## **SkyWater Technology Foundry Proposed Expansion**

**DRC – Submission: Project Narrative**

**Application Number: PL201900127**

SUBJECT:     **Application: PL201900127**  
                  SkyWater Technology Foundry, Inc.  
                  2401 and 2411 East 86<sup>th</sup> Street  
                  Pre-Application DRC Comments – June 25, 2019: **Responses**

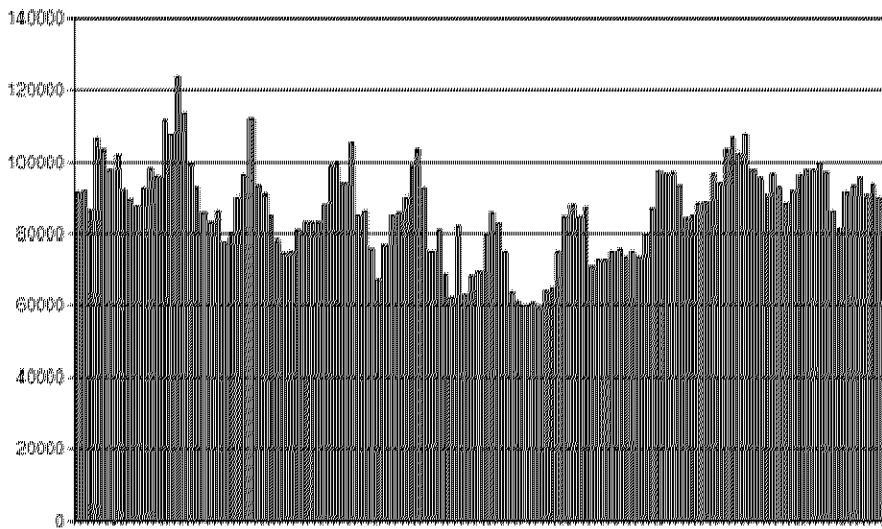
6. If meter data isn't possible would Skywater please share pumping data regarding pump starts and durations? Again this is to get an idea of the flow parameters from Skywater.

SkyWater does not have pump start and duration records. Only a totalizer for run time on each pump.
